Re: Turkey Point Units 3 & 4
Docket Nos. 50-250 and 50-251
Hot Channel Factor Normalized Operating Envelope

SAFETY EVALUATION

FIG. 3.2-3

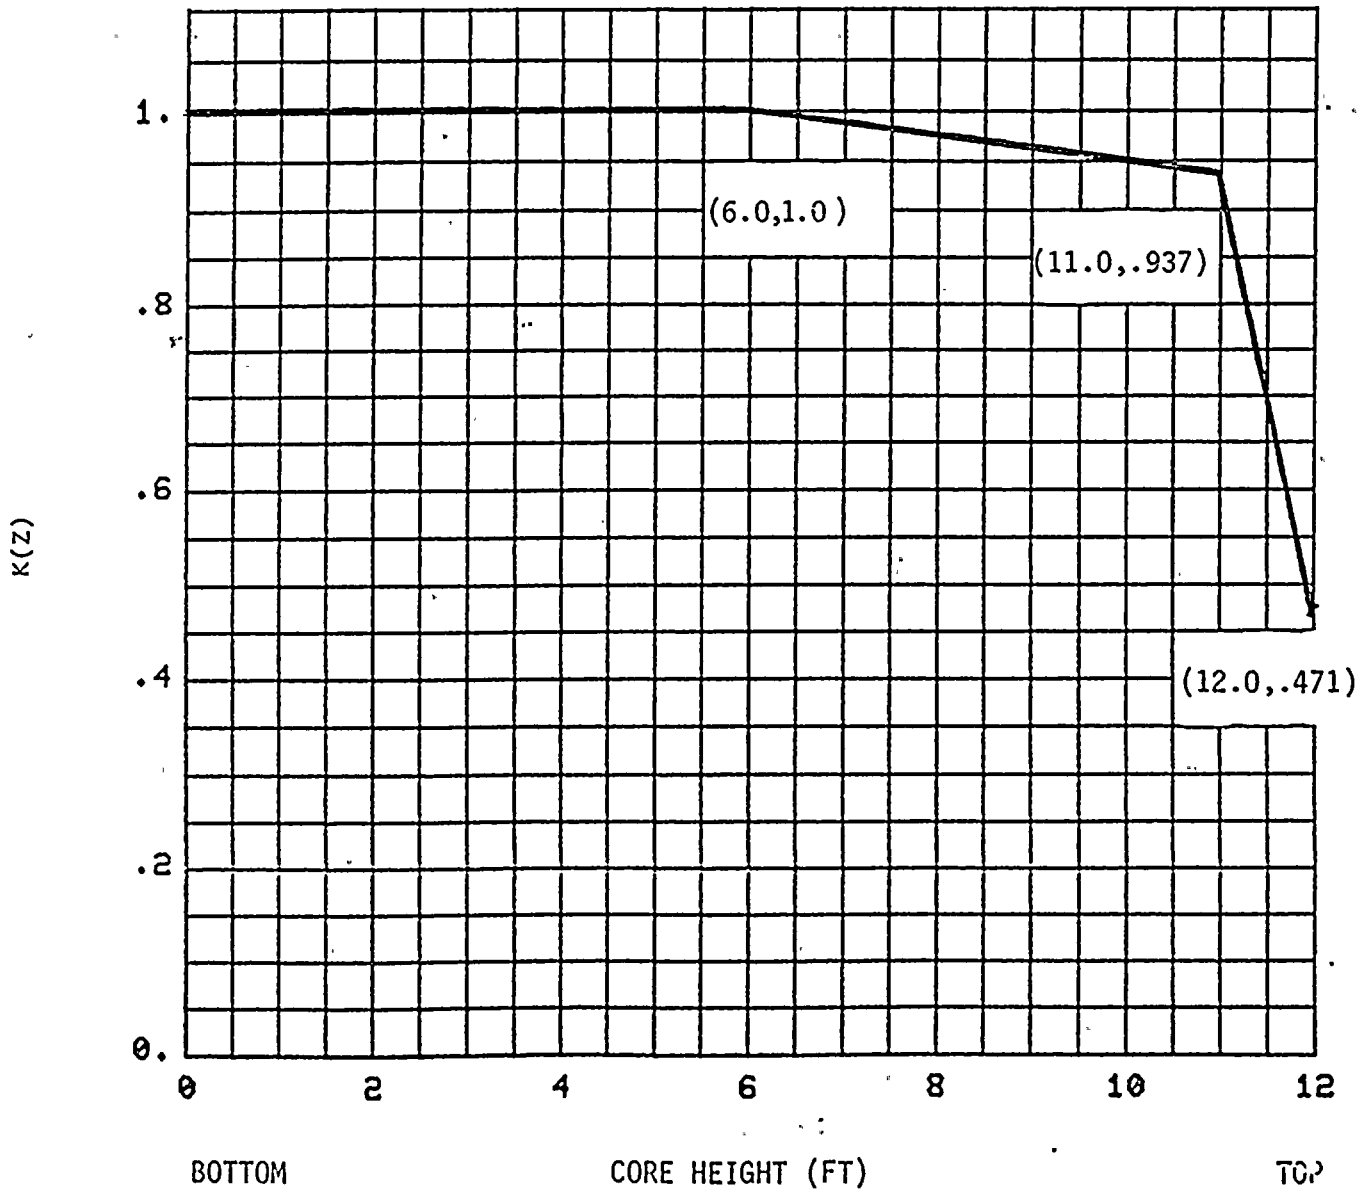
Following flux mapping at Turkey Point Unit 3 a discrepancy was noted in Figure 3.2-3, Hot Channel Factor Normalized Operating Envelope. The discrepancy was in the conservative direction, and while it posed no safety concern, the curve restricted power output of the unit. The proposed Technical Specification amendment substitutes the existing curve with that in the WCAP prepared for Cycle 8, our current cycle (WCAP's 10024 and 10056). This substitution has been discussed and agreed upon between Westinghouse and the NRC Staff.
